SECOND CHANGE APPLICATION REPORT

Drax Bioenergy with Carbon Capture and Storage

Document Reference Number: 8.15

Applicant: Drax Power Limited

Plate 2-7 - Extract from Current Land Plan for OHL2 Works - Plan 2.2 – Rev 02, Sheet 04

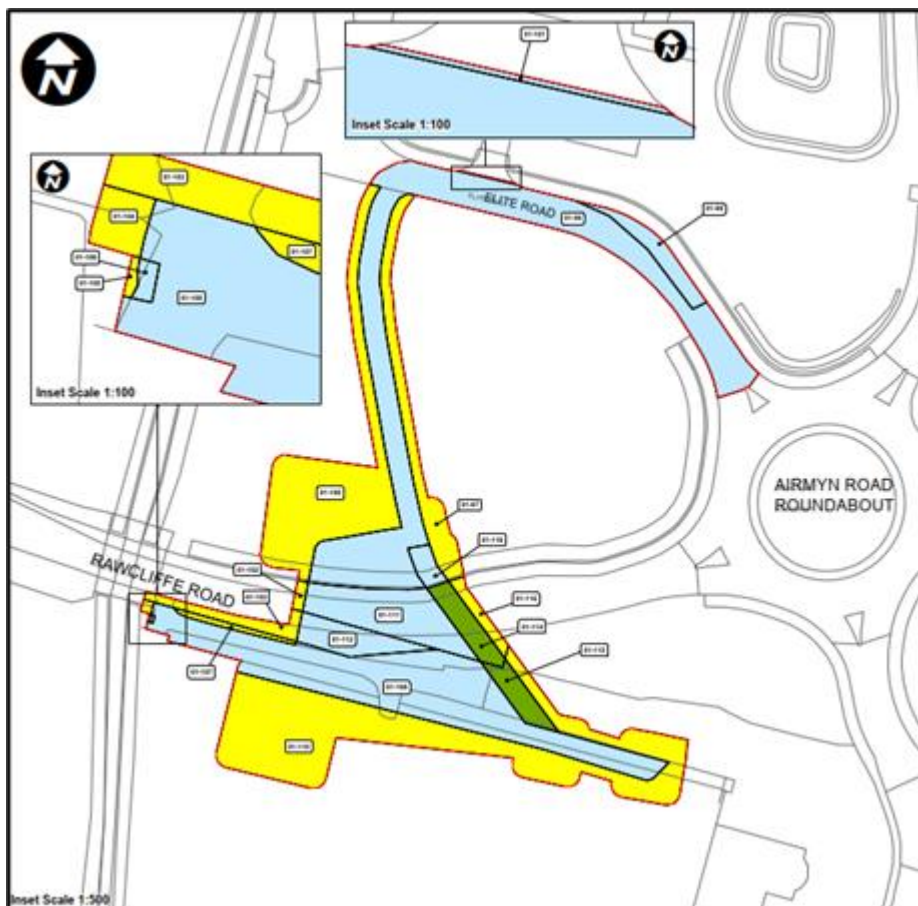
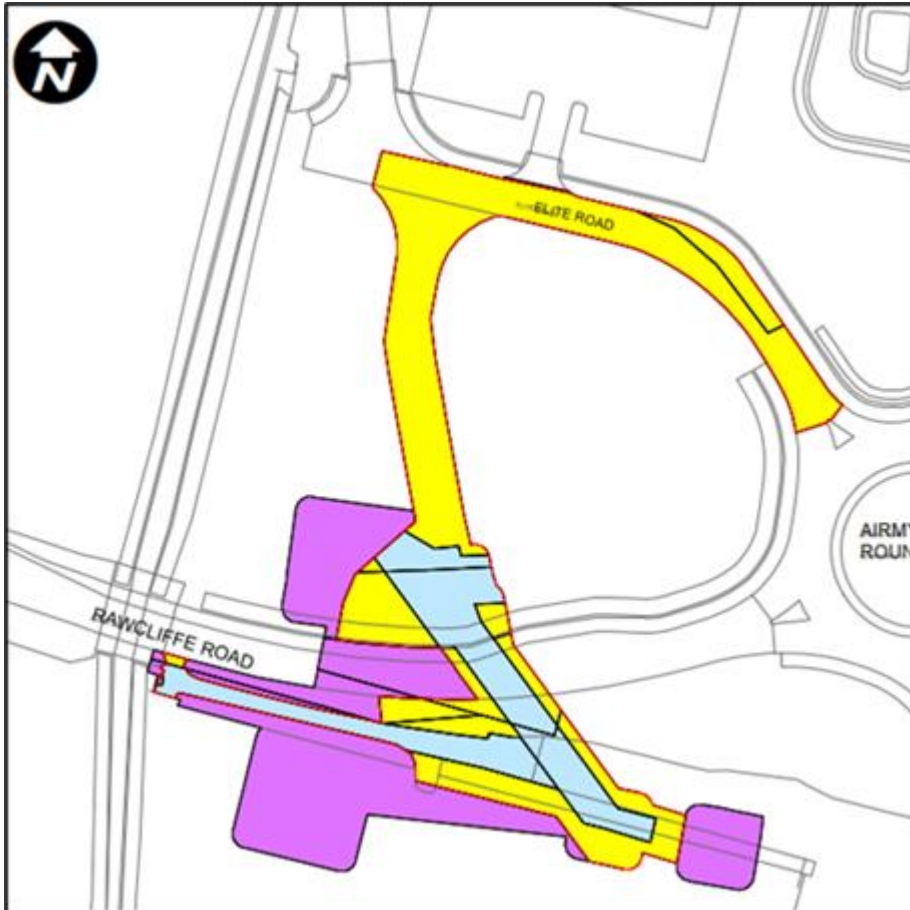
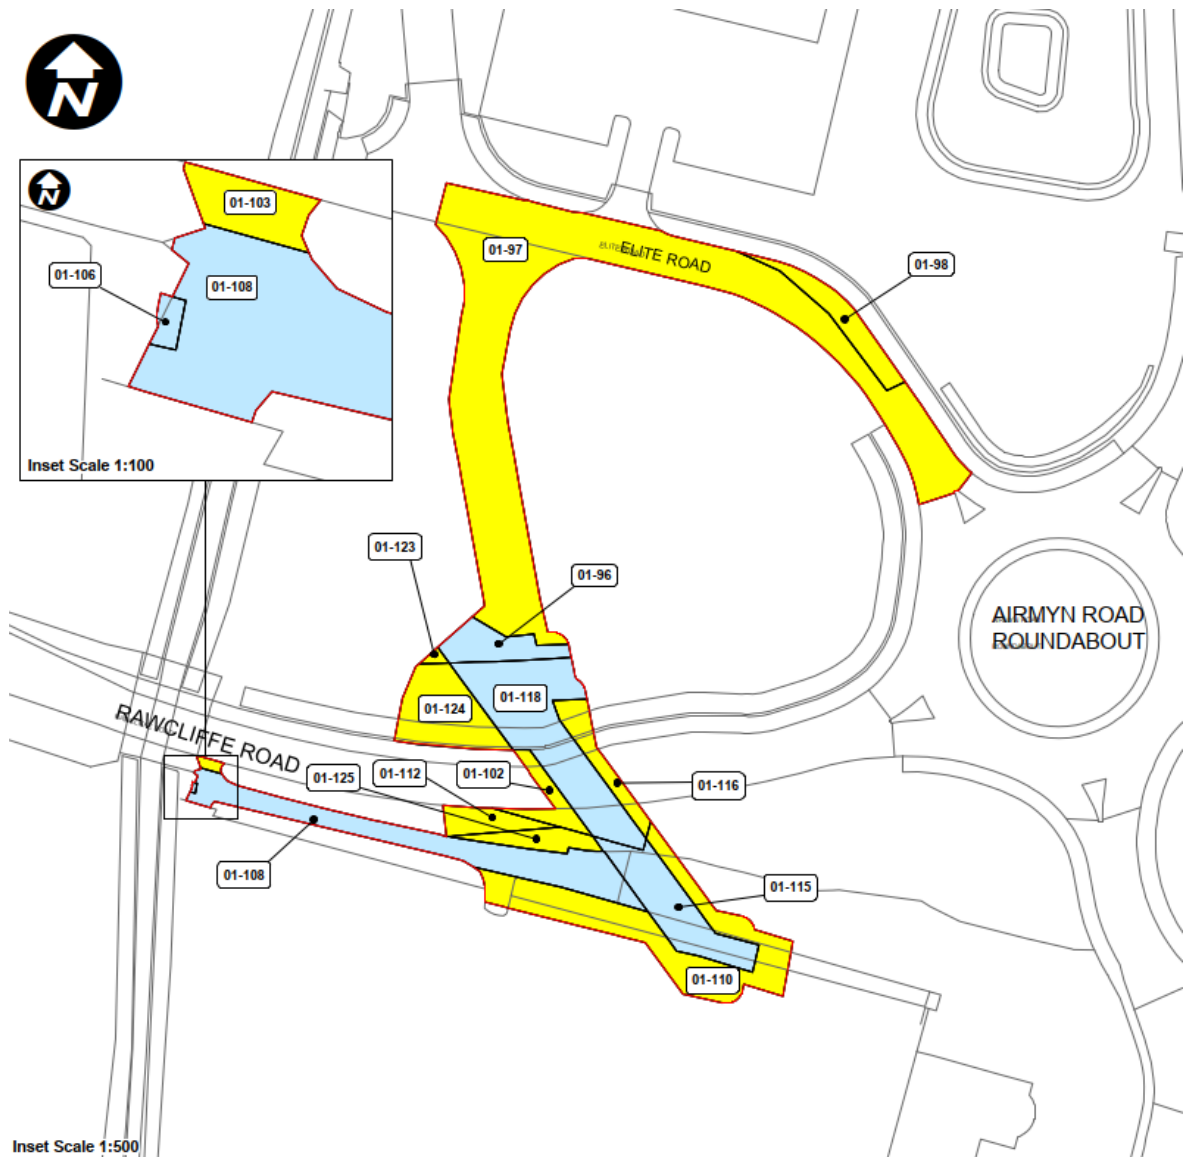
2.2.3. OHL2 is an existing electrical overhead line which crosses the A614 – Rawcliffe Road. Sheet 4 shows the areas of land affected by works for OHL2 (north and south of the A614). Below are extracts from the currently submitted Land Plans and extracts illustrating the proposed changes. The land identified in purple is no longer required for works and it is proposed to remove this land from the Order Limits. It can also be seen that the part of the areas of land previously proposed to be subject only to extinguishment of rights powers, is now sought to be subject to compulsory acquisition of rights powers, alongside an area of land north of Rawcliffe Road, required to enable the provision of the new undergrounded electrical cable and

connections to existing underground electrical cables at either end of the new undergrounded section which will replace the existing overhead lines and poles comprising OHL2. This land is required because the undergrounding of the cable is proposed within a 10m wide corridor of the existing alignment of OHL2, rather than via a route further to the west as proposed in the first Change Application. In addition, following the recent topographical survey, the dimensions of the bellmouth access from Elite Road into the land to the south have been amended to include a correction to reflect the actual access arrangements. This has resulted in the inclusion of a small amount of additional temporary land either side of the access within the land south of Elite Road, and a small area of land within Elite Road. The Change Application adjusts the land requirements at this location and an additional corresponding area north of the access within Elite Road to account for this additional work and to ensure consistency with the proposed temporary access route to be used to undertake the works to OHL2. This land is owned by an existing affected party - the consortium of Investors in Court House Farm/Delta Enterprise Park, and discussions are ongoing with this party regarding this matter.

- 2.3.14. The asset owner, Northern Powergrid's preferred design for the works has confirmed that undergrounding via a trenchless installation method such as HDD was not feasible due to other utility assets in the locality, and that the installation of the undergrounded section of the electrical cable would be via an open trench installation method across the Rawcliffe Road to connect to existing underground electrical cables at the northern and southern end of the existing overhead line. The asset owner has confirmed that it would prefer to retain the electrical infrastructure in its current alignment with the undergrounded section being across the highway also following the alignment of the existing overhead line within a 10m wide corridor to provide flexibility to adjust the exact routing to navigate around existing infrastructure in/under the highway and adjoining land.

- 2.3.15. The solution also includes already programmed works to electrical infrastructure on the southern side of Rawcliffe Road on land owned by JRS Services Ltd which includes the relocation of an electricity substation south-east of the most westerly wooden electricity pole in this location, and the connection to existing underground cables in the immediate vicinity.

- 2.3.16. On the southern side of Rawcliffe Road, works to facilitate the undergrounding of electrical infrastructure required to facilitate the AIL deliveries to Site on land owned by JRS Services Limited are limited to:

- a. Access via the existing access track off the A614 (to the east of Town Drain) the remaining wooden pole adjacent to the new substation;
 - b. Removal of the wooden pole; and

- c. Installation of undergrounded section of electricity cable to connect in to the existing electricity cable north of the new substation, and north-westwards via open trench installation methods.

- 2.3.17. There would therefore only need to be temporary rights of access to undertake the works, and permanent rights required to facilitate access to, and to maintain and repair the relevant section of the undergrounded electricity asset in perpetuity.

- 2.3.18. There is no longer a need for land to accommodate potential HDD/works compound on the southern or northern side of the A614 or a requirement to install any new wooden poles or above-ground electrical infrastructure in this location, and therefore these areas of land will be removed from the Order Limits.

Plate 2-10 - Extract from current ARoW Plan for OHL2 Works – Plan 2.4 – Rev P03, Sheet 05

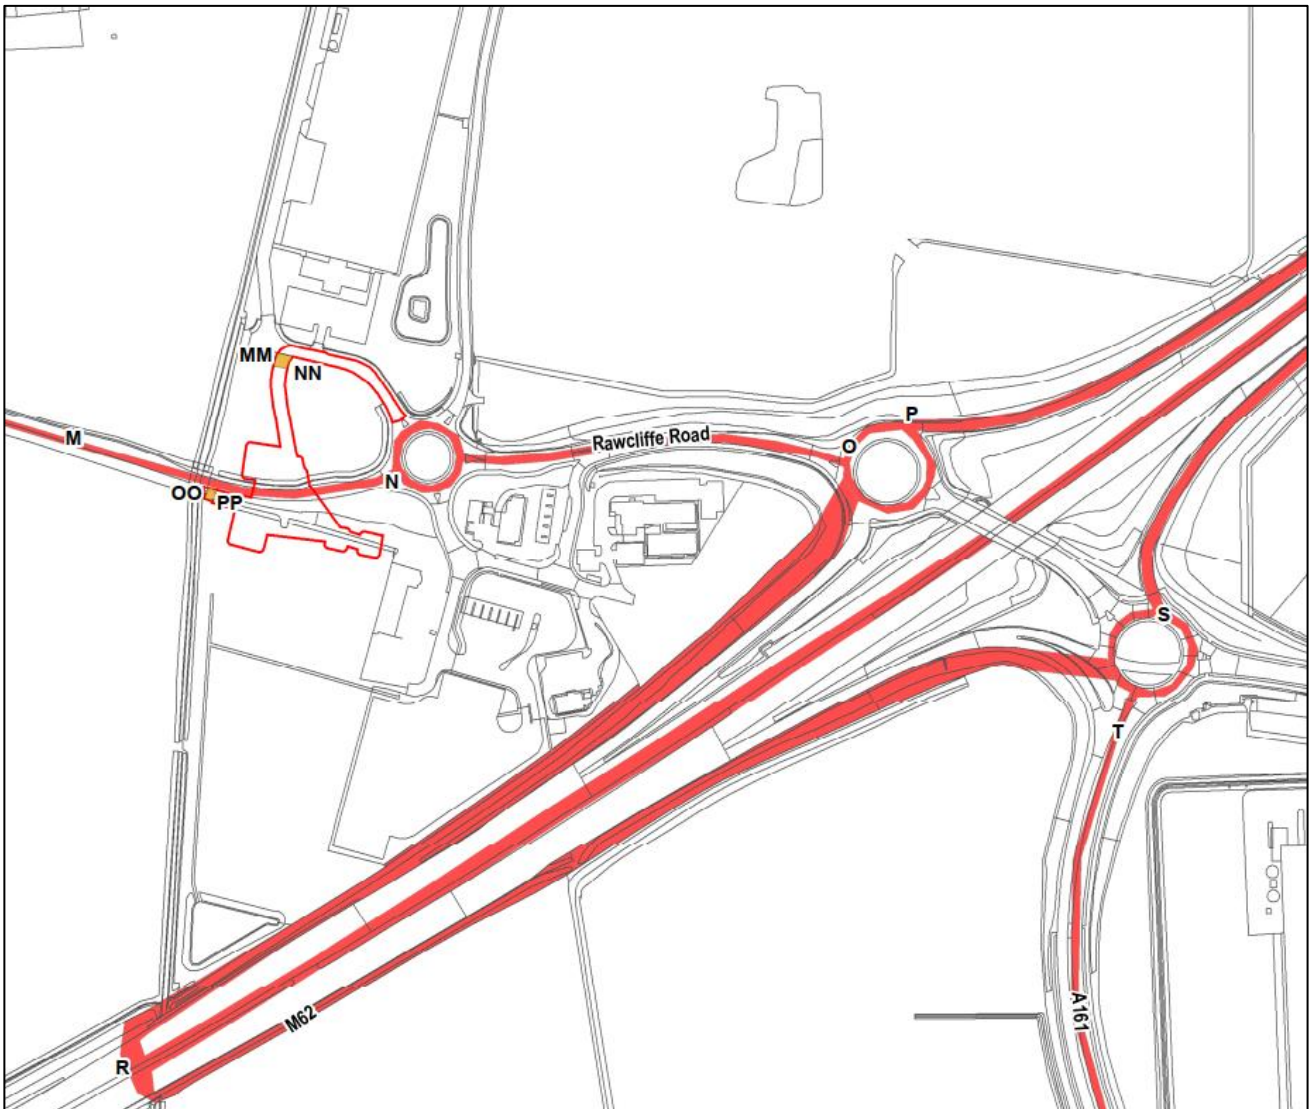
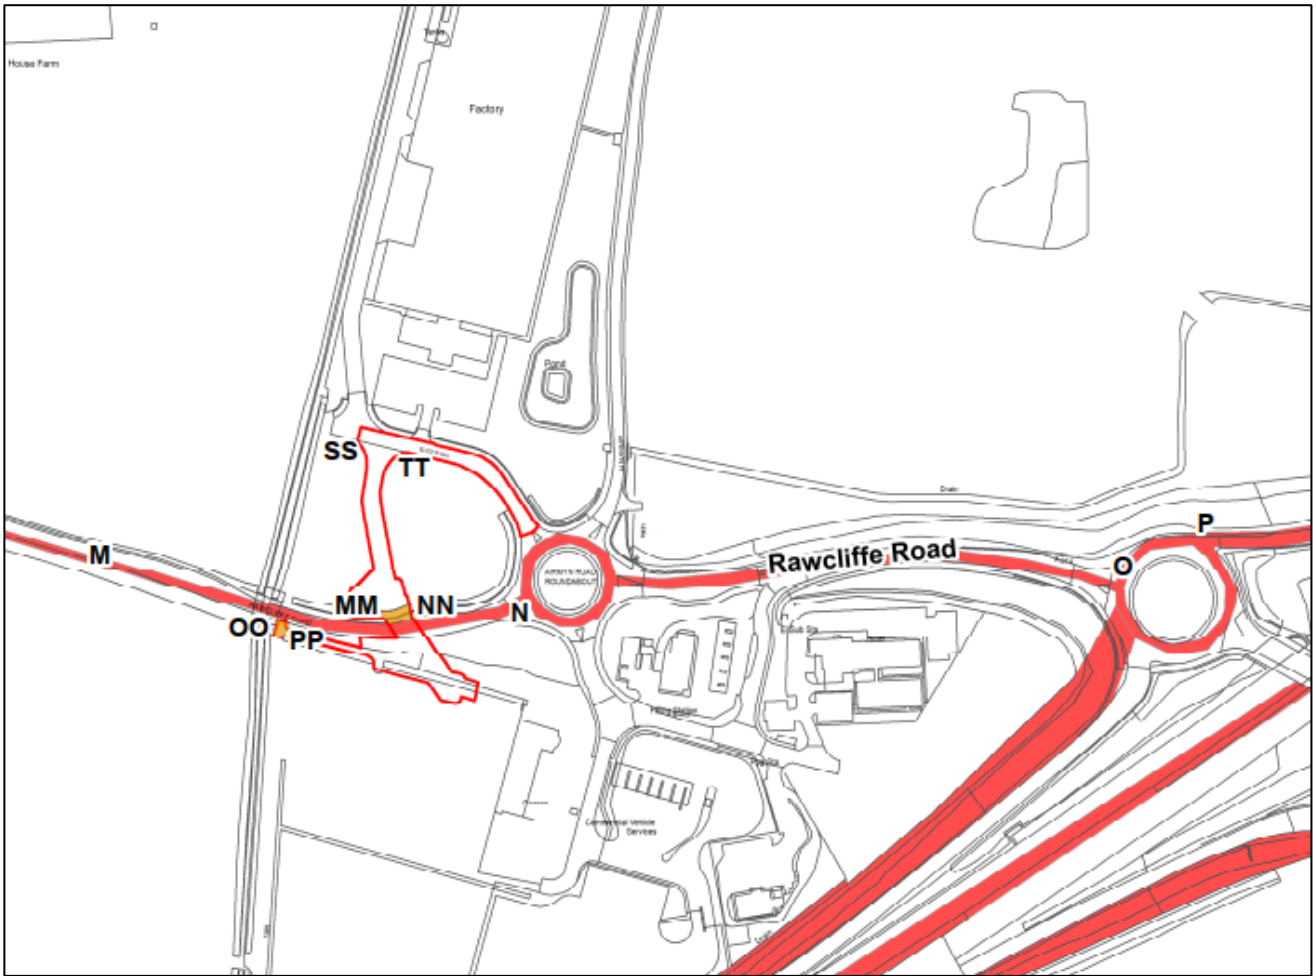
2.4	REP2-005	Access and Rights of Way Plans	Update of Sheets 4 and 5 to include revised Order Limits for Work No. 8 and amended access arrangements between relocated points MM and NN and SS and TT.

- 2.3.23. The realigned and undergrounded electrical infrastructure on the northern side of Rawcliffe Road will be located within land owned by ERYC and accessed via the highway verge. The previous route for accessing the altered configuration of electrical infrastructure once works have been completed on the northern side of Rawcliffe Road was via Elite Road, as shown on Plate 2-12 below, between points MM and NN. The updated access arrangements on the northern side of Rawcliffe Road for OHL2 is shown on the updated Access and Rights of Way Plan submitted with the SCA (see Plate 2-13, below, where the new access is shown between relocated points MM and NN). Therefore, there is no requirement to retain a permanent right of access over the land owned by the consortium of Investors in

Court House Farm/Delta Enterprise Park in perpetuity for the realigned underground sections of electrical infrastructure.
